**PRIVATE PLAN MODIFICATION 59**

**HEARING REPORT**

**ALBANY 10 PRECINCT**

**BEI GROUP LIMITED**

**Figure 2 Precinct Plan 3 - Height and building coverage control**

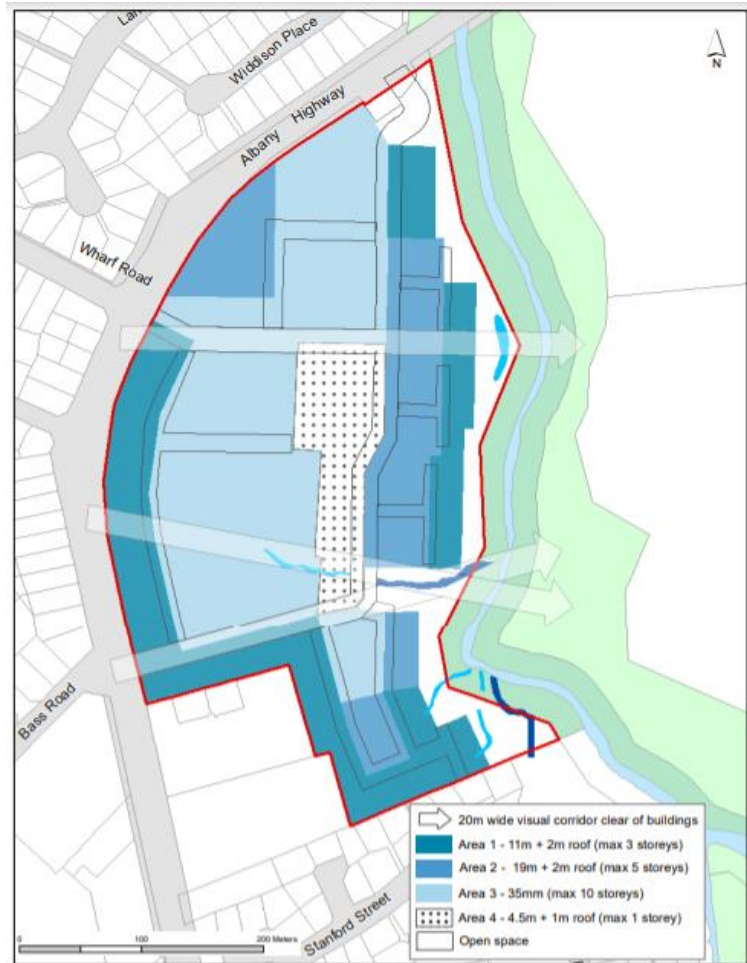
166. Before the Plan Change request was accepted, a Clause 23 request sought further analysis of the proposed height strategy and its relationship to the surrounding escarpments. The Clause 23 response provided greater clarity and analysis of building heights in relation to the Fernhill Escarpment. Ms Skidmore indicates that the proposed precinct provisions will enable building heights that are considerably higher than the escarpment. Ms Skidmore concludes that the distribution of height across the Site with a generous setback of Height Area 3 (with lower height limits closer to the escarpment) provides a suitable transition to the landform. Please refer to figure 2 of Precinct Plan 3 – Height and building coverage control below that demonstrates the distribution of height areas in relation to the Fernhill Escarpment.

167. Ms Skidmore is satisfied that the Masterplan provides a clear analysis of the Site's relationship to the surrounding context, which has been appropriately assessed. It is also concluded by Ms Skidmore that the detailed provisions proposed for the precinct suitably manage the effects and, importantly, give effect to the RPS of the AUP, specifically what Ms Skidmore considers a key RPS objective, B2.2.1(1) which is as follows:

**Figure I522.6.3.1 Maximum building dimension plan view**

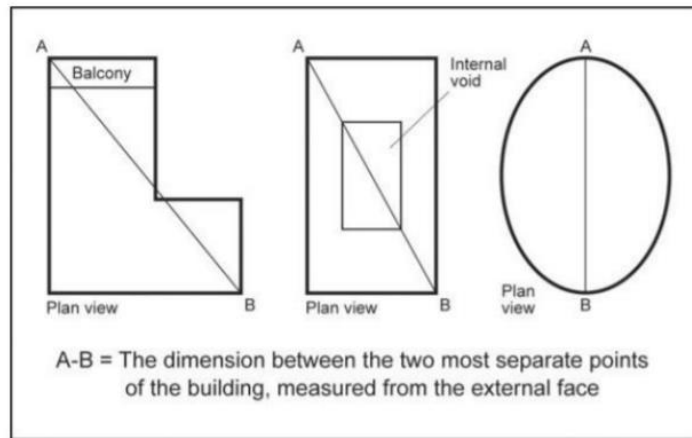
418. **Submission 73.48** seeks amendments to standard I552.6.3. No rationale has been provided for these amendments; however, I recognise that the amendments make the standard clearer for plan users when considered the amendments sought against Figure I552.6.3.1 *Maximum building dimension plan view*, as set out below:

419. For clarity reasons, I agree with the submitter that including “A to B in Figure I552.6.3.1 Maximum building dimension plan view” in the standard improves the interpretation of the standard and recommend that submission 73.48 be accepted.

**Figure I552.6.5.1 Building setback at upper levels**

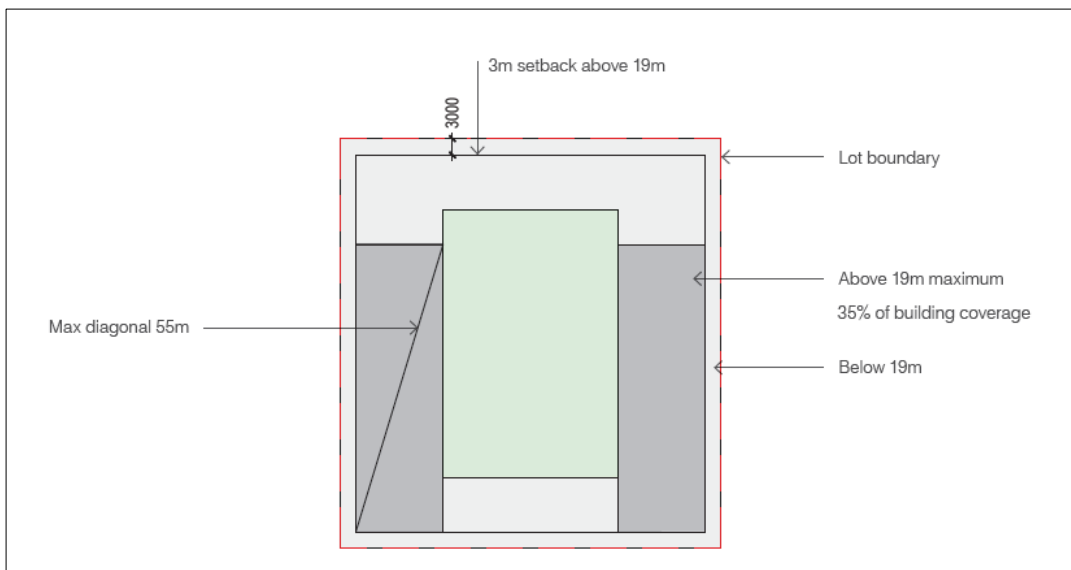
386. **Submission 73.51** seeks amendments to Standard I552.6.5 and Figure I552.6.5.1 Building set back at upper level to:
- a. Recreate the figure (and without colour), and add another explanatory graphic to it to be readily interpreted and administered.
